Access Compliance Report Public Rights-of-Way (Curb Ramps)

Main Street: BRADBURY_RD		Cross Street: OLD_MILL_RD		Location:	NW
ADA ID: RPRK211209135759	Ramp Type: Type 4 - Parallel	Initial Pass/Fail: Fail	Overall Compliance: No	Severity Score:	15

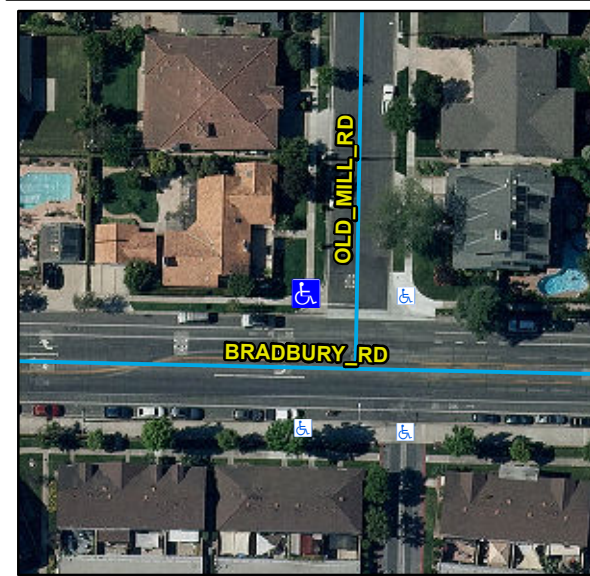
Compliance	Description	Data	Compliance	Description	Data
N/A	Ramp Length LT (in)	108	N/A	Ramp Length RT (in)	111
Yes	Ramp Width LT (in)	104	Yes	Ramp Width RT (in)	104
Yes	Ramp Run Slope LT (%)	0.4	Yes	Ramp Run Slope RT (%)	7.2
No	Ramp Cross Slope LT (%)	4	No	Ramp Cross Slope RT (%)	5.9
N/A	Landing Present	N/A	N/A	DWS Provided	N/A
N/A	Landing Length (in)	N/A	N/A	DWS Contrast	N/A
N/A	Landing Width (in)	N/A	N/A	DWS Length (in)	N/A
N/A	Landing Run Slope (%)	N/A	N/A	DWS Full Width	N/A
N/A	Landing Cross Slope (%)	N/A		DWS Offset Type	N/A
N/A	Landing Movement Obstructed?	N/A	N/A	DWS Offset Left (in)	N/A
	Landing Movement Type	N/A	N/A	DWS Offset Right (in)	N/A
N/A	Landing Shared	N/A			
N/A	Clear Space	Yes			
N/A	Clear Space To Crosswalk (in)	N/A			
N/A	Marked Crosswalk 1	No	N/A	Marked Crosswalk 2	No
	Crossing 1 Direction	S		Crossing 2 Direction	E
	Marked Crosswalk 1 Width (in)	N/A		Marked Crosswalk 2 Width (in)	N/A

Remove & Replace Curb Ramp With Two New Directional Ramps or Equivalent.
